Amendments to the Wastewater Master Plan For the London Area

Planning Commission Presentation March 21, 2018

Proposed Master Plan

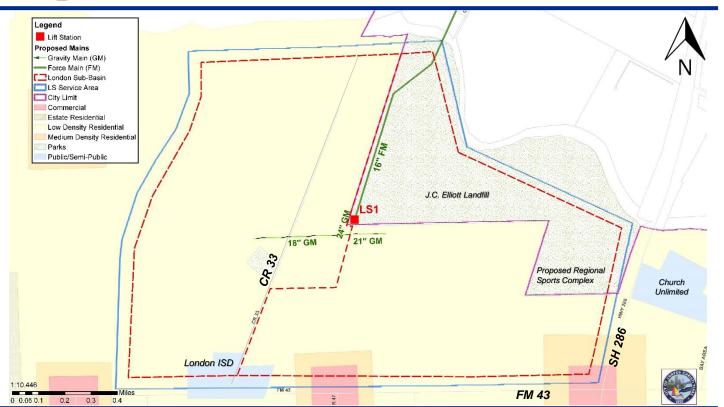
- 1. Correct service area to include City Landfill property south of the Oso Creek.
- 2. Delineate sub-basin boundaries within the service area.
- 3. Relocate the lift station approximately 1/4 mile south.
- 4. Increase <u>west</u> gravity line from 15" to 18" diameter.
- 5. Increase <u>east</u> gravity line from 15" to 21" diameter <u>and</u> reduce its length to approximately 100'.
- 6. Increase the <u>north-south</u> gravity line that ties into lift station from 15" to 24".
